New Reactors Division

**Step 4 Assessment of Radiological Protection for the UK Advanced Boiling Water
Reactor**

Assessment Report: ONR-NR-AR-17-021
Revision 0
December 2017

Figure 2: Hitachi-GE ALARP Process Flow Diagram (Ref. 47).

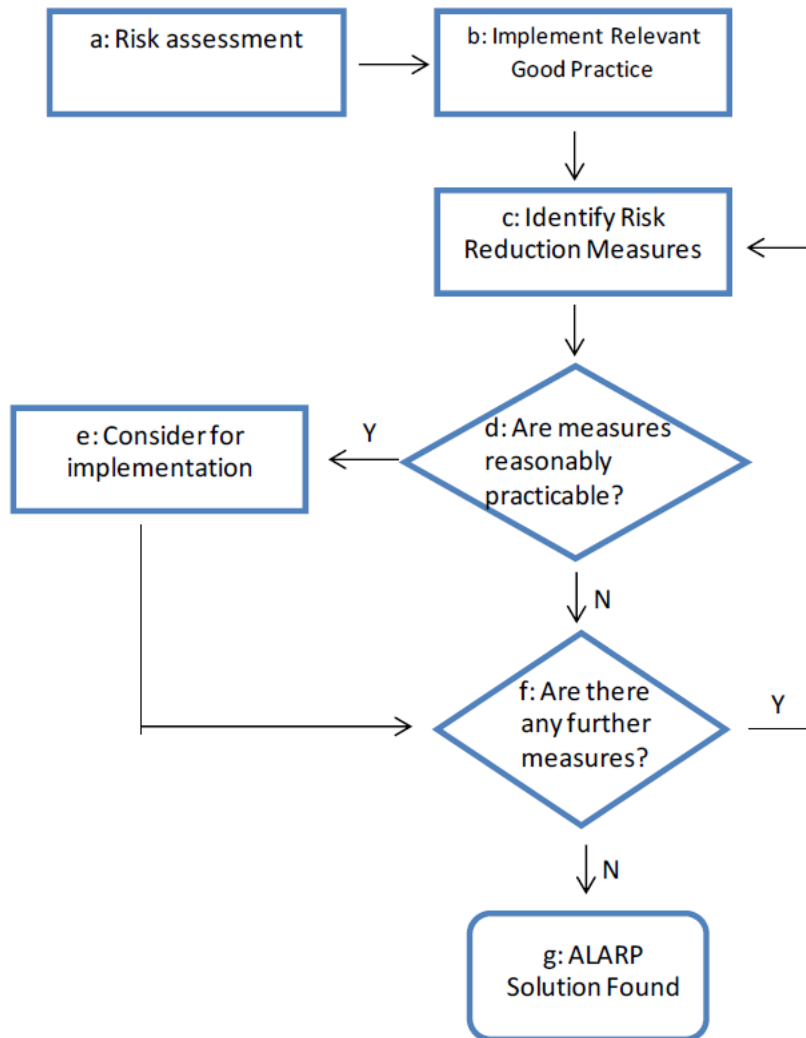
121. From a radiological protection perspective, the methodology presented is conceptually reasonable and consistent with UK standards. Shortfalls were however identified when the methodology was developed and applied in detail, notably in Contamination Control and Protection against Direct Radiation (Ref. 51). It was found that whilst collective dose over the plant lifetime versus difficulty of implementation may be a useful aid in making ALARP judgements, the dose bands used must be relevant to the task being considered. Collective dose bands that may reasonably be applied at plant level, as per Topic Report: Demonstration to Ensure that External and Internal Doses are ALARP (Ref. 46) (i.e. up to 2 man-Sv, 2 man-Sv to 20 man-Sv and over 20 man-Sv) are not meaningful when applied at system or task level as they will effectively screen out options that may in fact be reasonably practicable and reflect Relevant Good Practice (RGP).

122. Review of this document led to RQ-ABWR-0960 - Application of ALARP Methodology at Task Level (Ref. 52) on the application of the “traffic light” approach to qualitative ALARP assessment detailed in section 7.1 of GDA ALARP Methodology (Ref. 48). This resulted in Hitachi-GE changing its methodology for occupational exposure, as described in the RQ response UK ABWR ALARP Demonstration Methodology (Ref. 53). I considered the new approach to be appropriate.
